Proposed Revisions to a Standard Plans Index

Index Number: 676-010

Index Title: CABINET INSTALLATION DETAILS

Summary of the changes:

POLE MOUNTED CONTROLLER CABINET

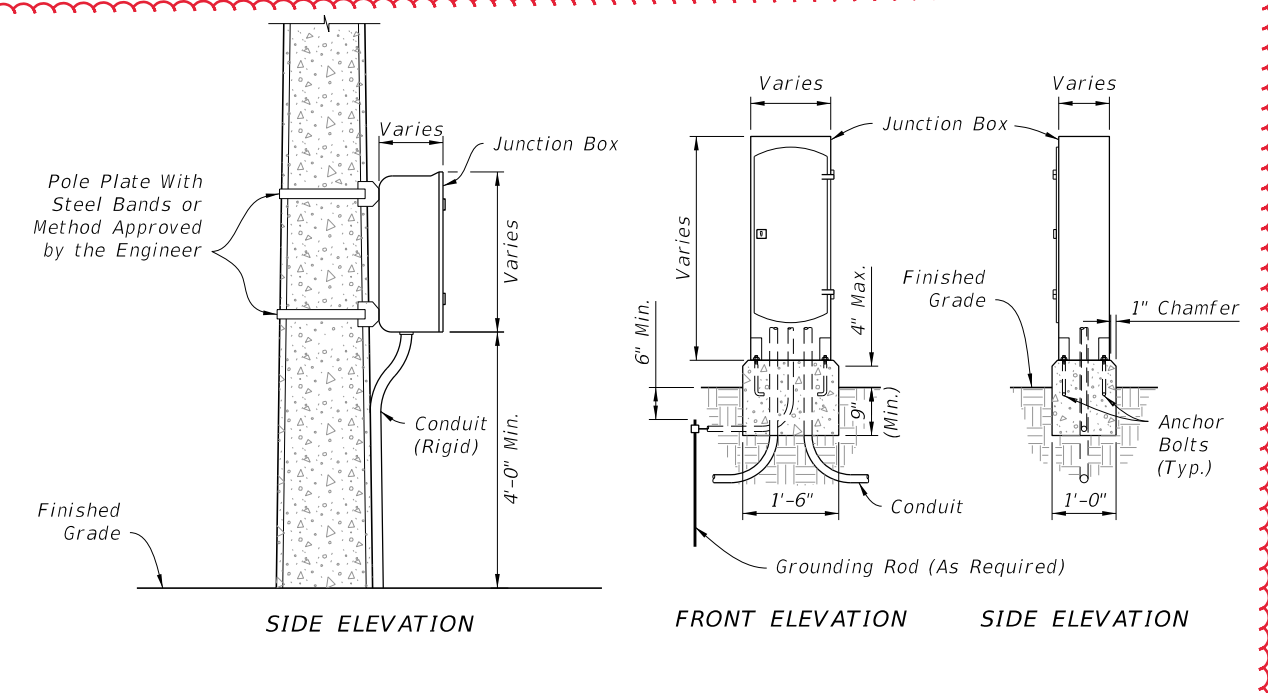
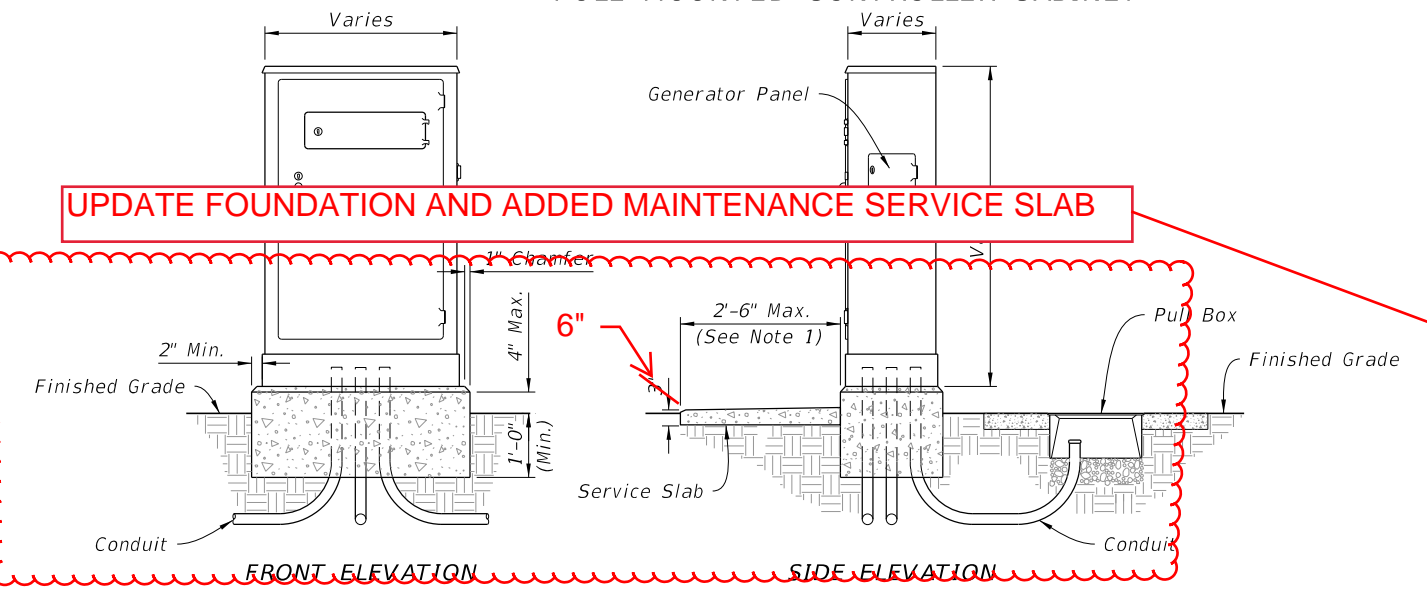
Sheet 1: Changed concrete thickness in the GROUND and POLE MOUNTED CONTROLLER CABINET detail; Added Maintenance Service Slab; Updated Notes; Renumbered sheet.

UPDATE FOUNDATION AND ADDED MAINTENANCE SERVICE SLAB

UPDATED NOTES

UPDATE FOUNDATION AND ADDED MAINTENANCE SERVICE SLAB

NOTES:
 1. Service Slab: slope 1/4" to 1" for drainage. Not required in sidewalk, pavement areas, or where R/W is restricted.
 2. The number, size and orientation of conduit sweep will vary according to site condition or locations. Provided two spare 2" PVC conduits in all bases. Place the exits of the spare conduits in the direction of the center rear of the cabinet base and into a pullbox. If obstructions prevent the spare conduit from exiting to the rear, or the rear of the cabinet is located on the R/W line, locate as directed by the Engineer. Cap all spare conduit sweeps with a weatherproof fitting.

GROUND MOUNTED CONTROLLER CABINET

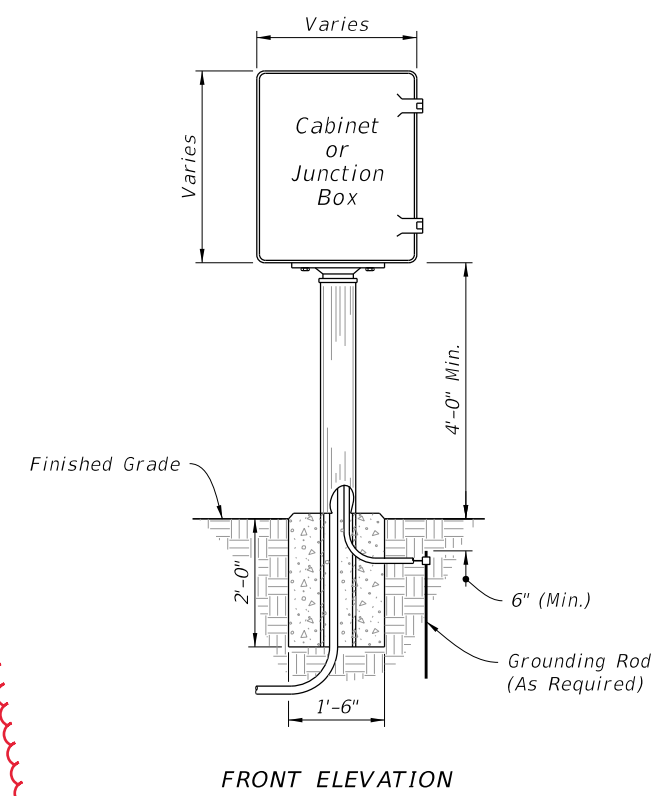
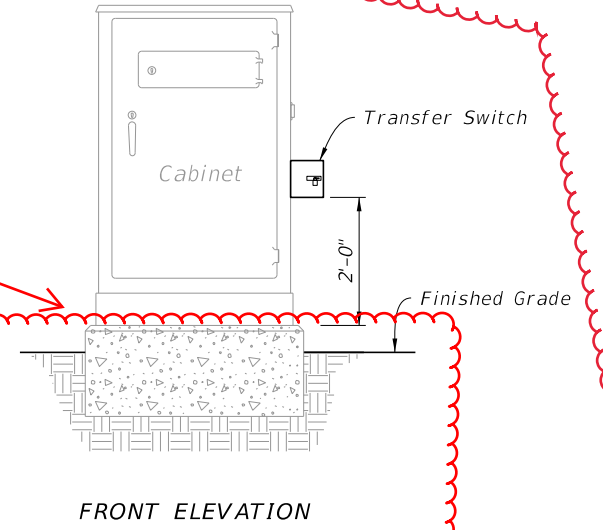
UPDATED NOTES

POLE MOUNTED INTELLIGENT TRANSPORTATION SYSTEMS (ITS) CABINET

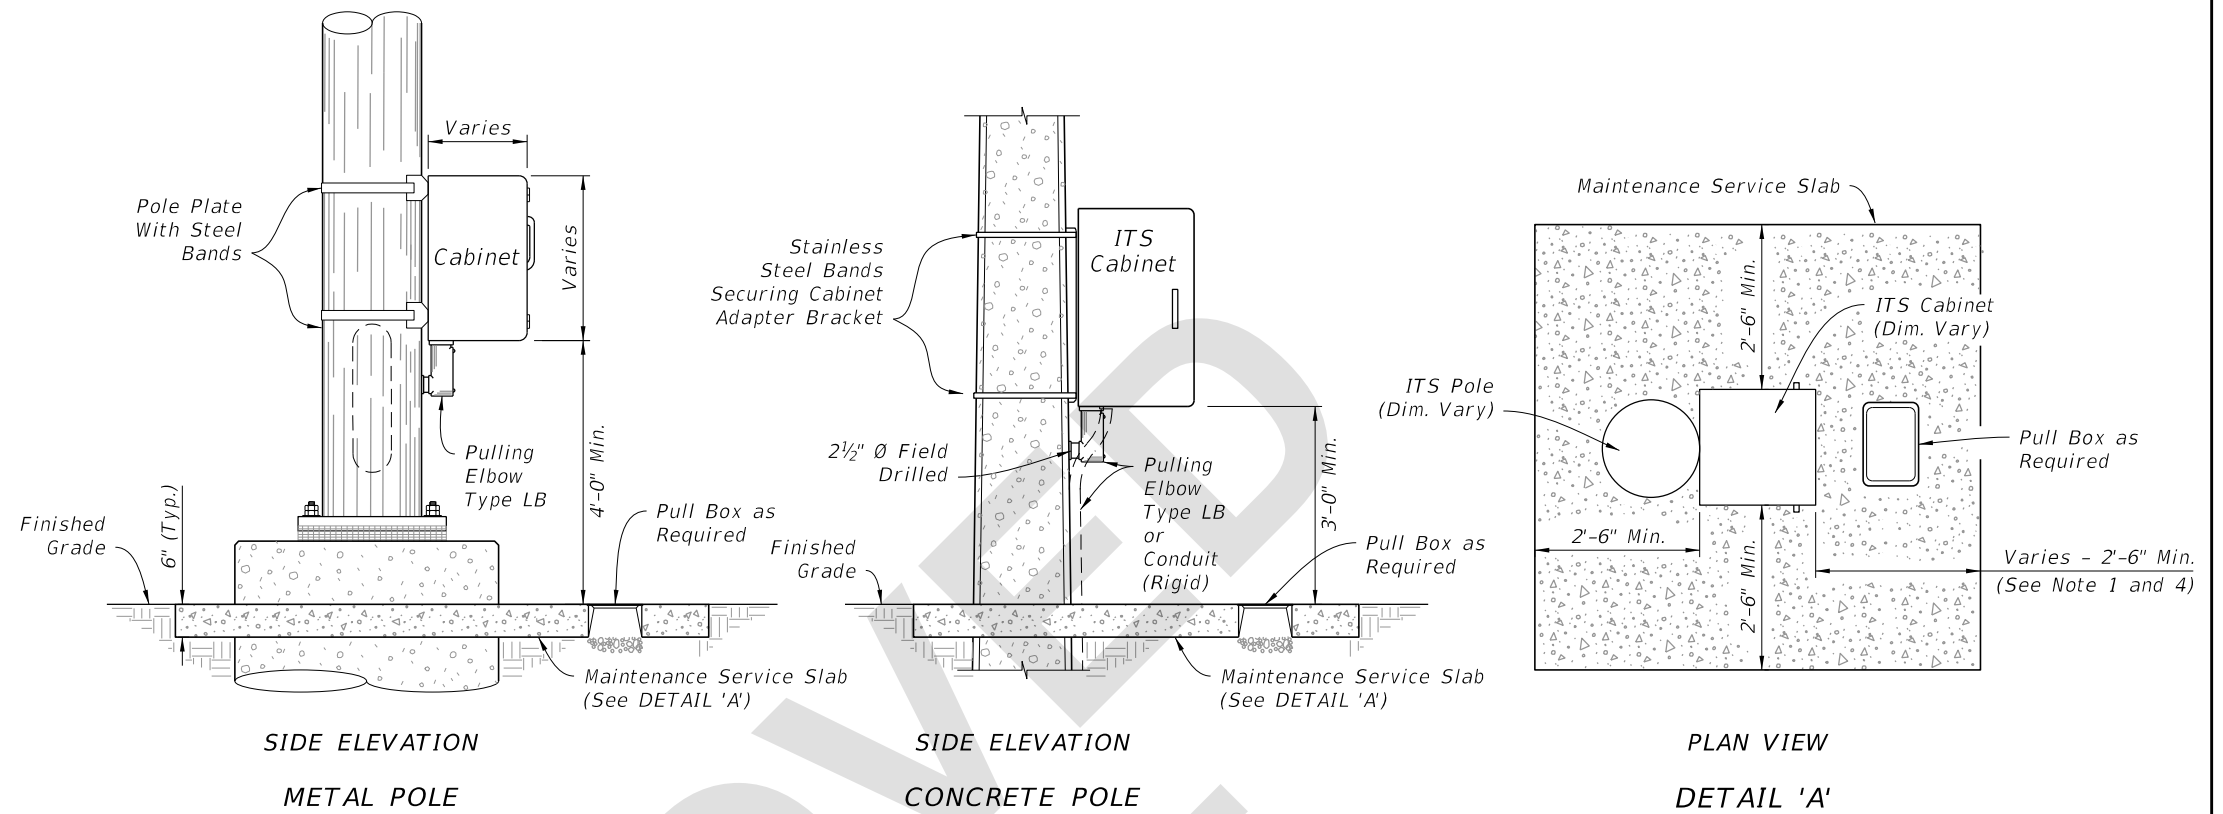
Sheet 2: New Sheet - details for Intelligent Transpiration System (ITS) cabinets and service slab requirements.

1. Maintenance Service Slab: Use Class NS concrete and slope 1/4" to 1" for drainage. Not required in sidewalk, pavement areas, or where R/W is restricted.
2. If cabinet mounting requires relocation of hole in concrete pole, fill existing hole with concrete or cover with a noncorrosive cover plate.
3. Liquidtight flexible conduit is approved for use from the electrical disconnect to the cabinet when both are installed on the same pole.
4. Where a pull box is to be placed within the maintenance service slab, the slab width must be extended to provide for the required pull box concrete apron as detailed in Index 635-001.
5. Coordinate placement of maintenance service slab with proposed final grade. Grade and compact side slopes around the maintenance service slab to provide a stable and level working area and tie into the proposed embankment.

GROUND MOUNTED INTELLIGENT TRANSPORTATION SYSTEMS (ITS) CABINET

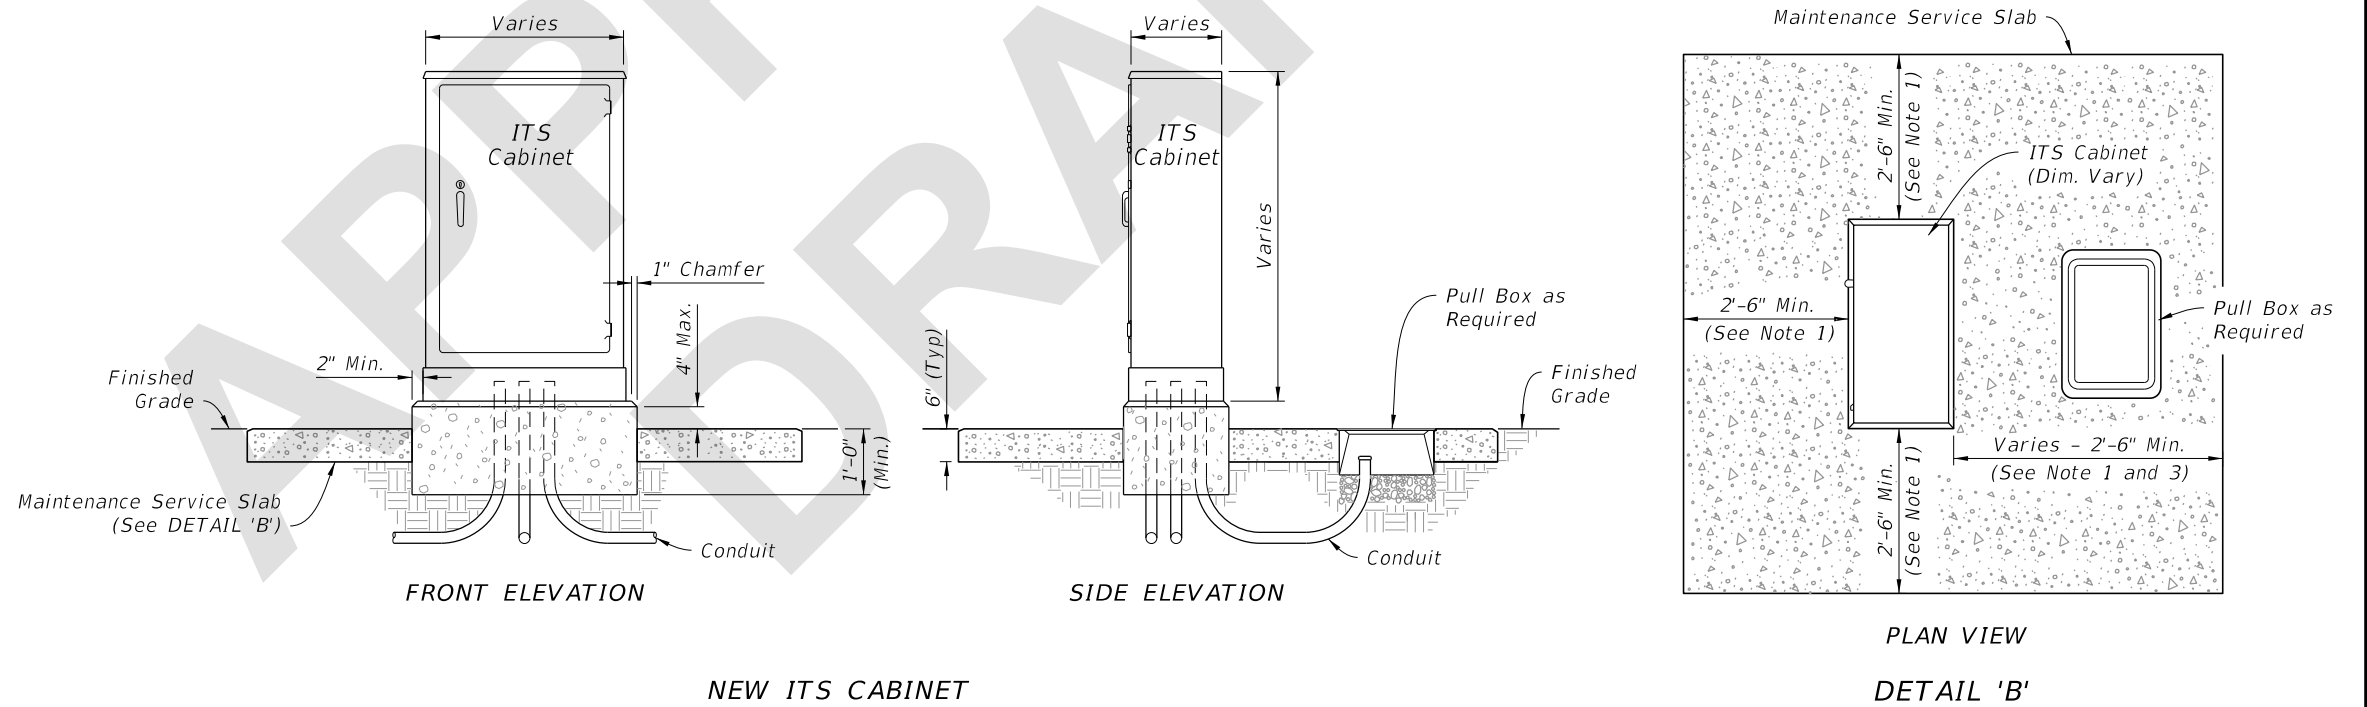
NEW ITS CABINET

1. Maintenance Service Slab: Use Class NS concrete and slope 1/4" to 1" for drainage. Not required in sidewalk, pavement areas, or where R/W is restricted.

2. The number, size and orientation of conduit sweep will vary according to site condition or locations. Provided two spare 2" PVC conduits in all bases. Place the exits of the spare conduits in the direction of the center rear of the cabinet base and into a pull box. If obstructions prevent the spare conduit from exiting to the rear, or the rear of the cabinet is located on the R/W line, locate as directed by the Engineer. Cap all spare conduit sweeps with a weatherproof fitting.

3. When a pull box is to be placed within the maintenance service slab, the slab width must be extended to provide for the required pull box apron as detailed in Index 635-001.

4. Coordinate placement of maintenance service slab with proposed final grade. Grade and compact side slopes around the maintenance service slab to provide a stable and level working area and tie into the proposed embankment.

SHEET
3 of 3

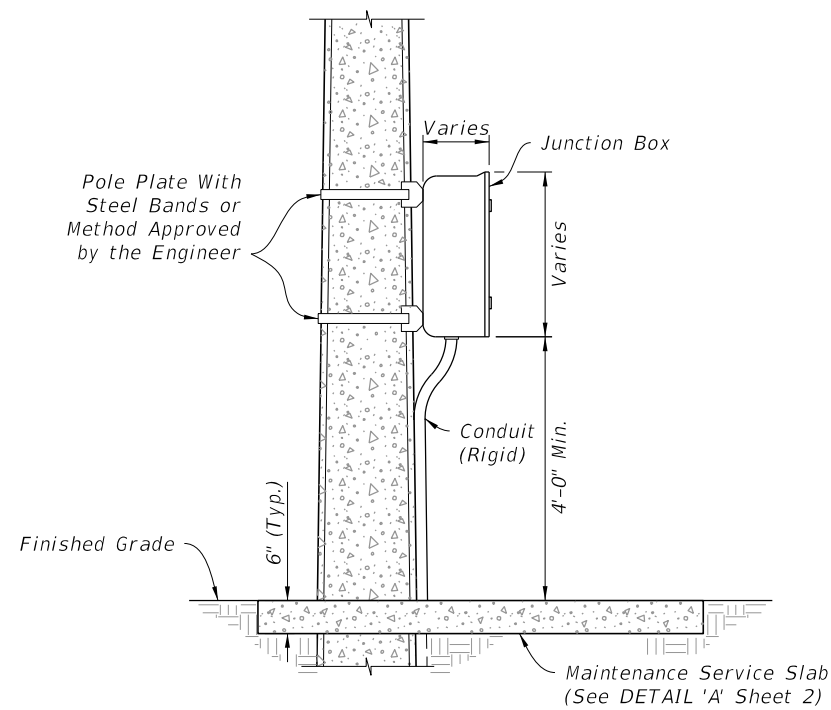
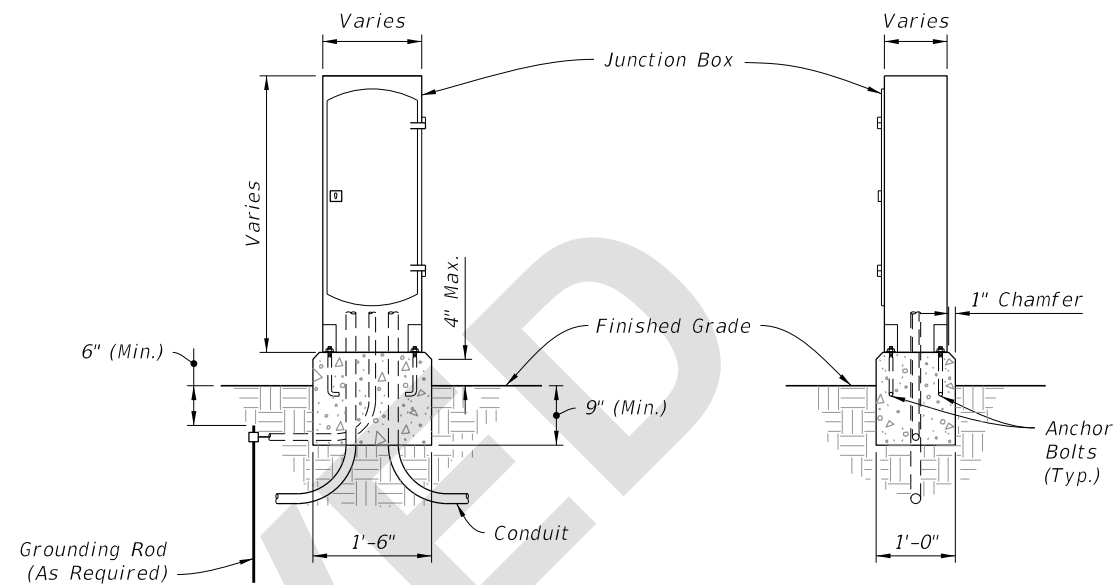
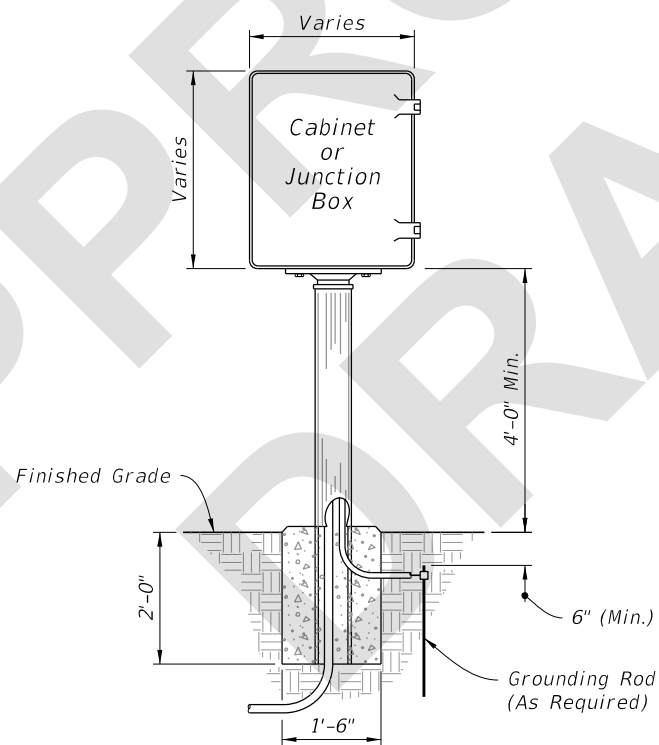
Sheet 3: New Sheet - INTERCONNECT JUNCTION BOX and PEDESTAL MOUNTED CABINET Details.

NEW SHEET 3
